Duke Power
Catawba Nuclear Station
4800 Concord Road / CN01VP
York, SC 29745-9635

Subject: Duke Energy Corporation
Catawba Nuclear Station, Units 1 and 2
Docket Numbers 50-413 and 50-414
Proposed Technical Specification Amendment
Technical Specification 3.7.16, Spent Fuel
Assembly Storage, and 4.3, Fuel Storage

MARKUP of TECHNICAL SPECIFICATIONS PAGES FOR CATAWBA

Table 3.7.16-1

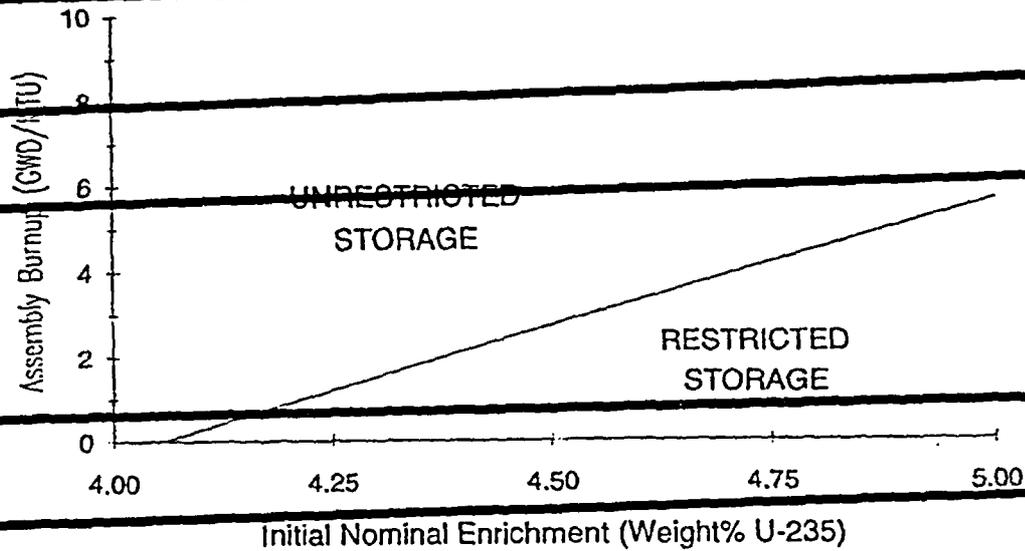
- **Table 3.7.16-1:** As discussed above, this table is deleted. The revised criticality analysis described in Attachment 4 removes any burnup requirements from Unrestricted storage of LEU fuel.

DELETE THIS TABLE

Table 3.7.16 ← 1

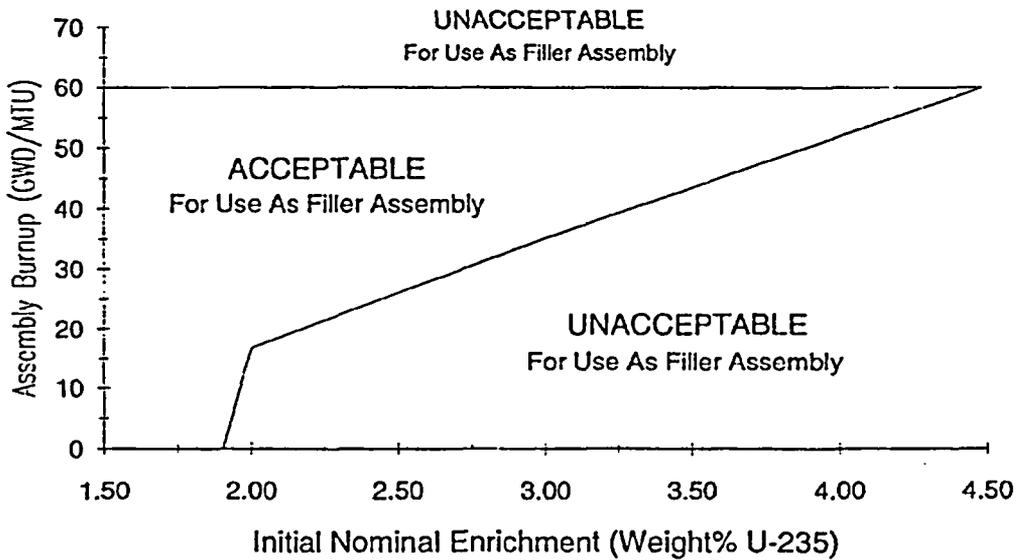
- **Table 3.7.16-2:** This table currently defines minimum burnup requirements for LEU assemblies to qualify as Filler fuel for the Restricted / Filler storage configuration shown in TS Figure 3.7.16-1. This table is retained here, for compatibility with the approved TS changes for the MOX LTAs (Reference 1), which specify that MOX LTAs must be stored as Restricted assemblies, with LEU fuel assemblies as Fillers. However, because TS Table 3.7.16-1 is eliminated, TS Table 3.7.16-2 will be renumbered as TS Table 3.7.16-1.

Figure 3.7.16-1
Required 3 out of 4 Loading Pattern for Restricted Storage

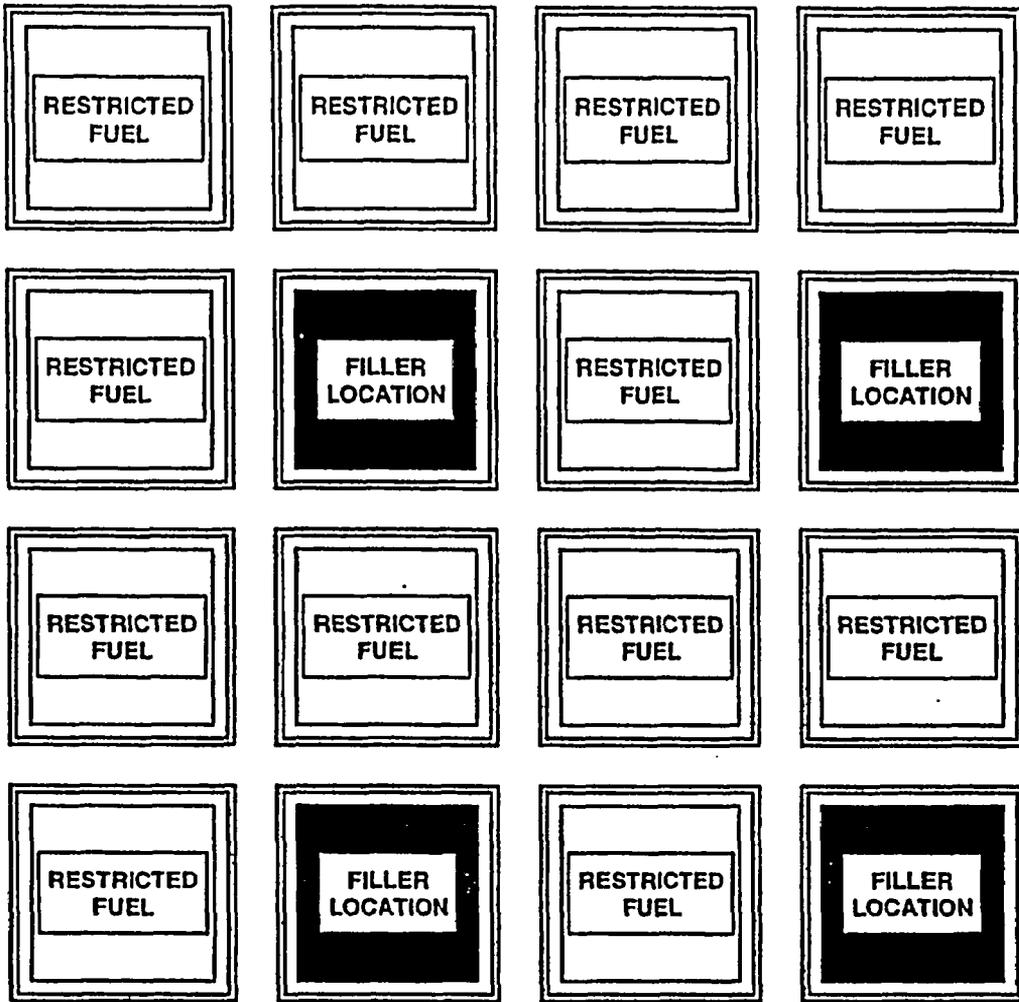
- **Figure 3.7.16-1:** This figure illustrates the loading configuration for Restricted / Filler fuel storage in the Catawba SFPs. The definition of Restricted fuel is revised on this figure, to remove the reference to current TS Table 3.7.16-1. As noted above, the revised Catawba SFP criticality analysis eliminates the need to store any LEU fuel as Restricted fuel.

Any row bounded by an Unrestricted Storage Area shall contain a combination of ~~restricted fuel assemblies~~ and filler locations arranged such that no ~~restricted fuel assemblies~~ are adjacent to each other. Example: In the figure above, row 1 or column 1 can not be adjacent to an Unrestricted Storage Area, but row 4 or column 4 can be.
